REMARKS

Amendments to the Drawings, Specification and Claims

U.S. Serial No. 10/055,411 Inventors: Hoisignton et al.

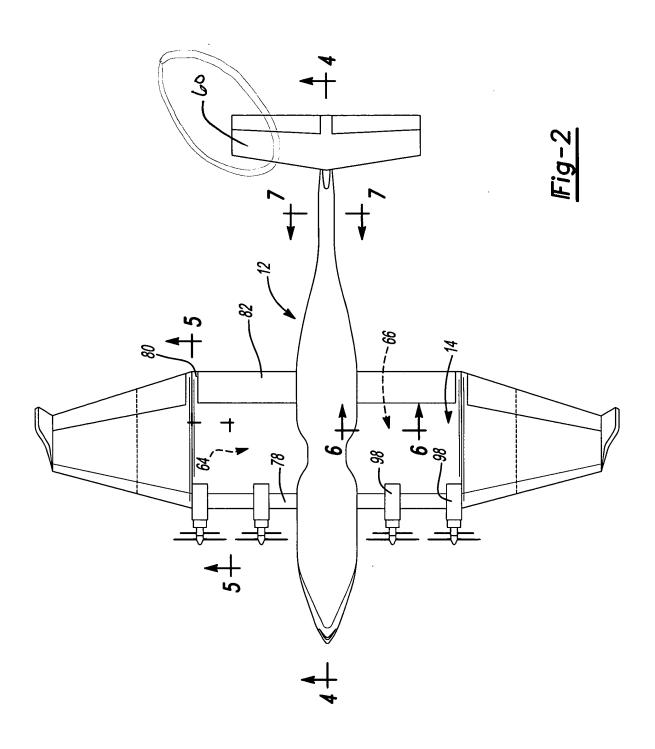
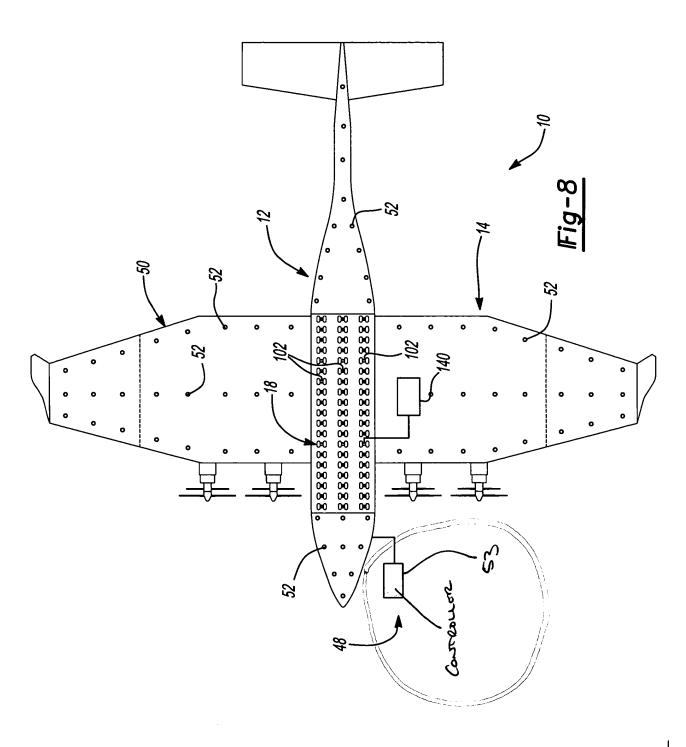
The Examiner has objected to the drawings for failing to show reference numerals 53 and 60, which are associated with a controller and a horizontal stabilizer, respectively.

Enclosed please find two sheets of drawings with proposed corrections marked in red. Support for the changes can be found in the application as originally filed and as such, no new matter has been added. Applicant therefore submits that the objection to the drawings has been rendered moot.
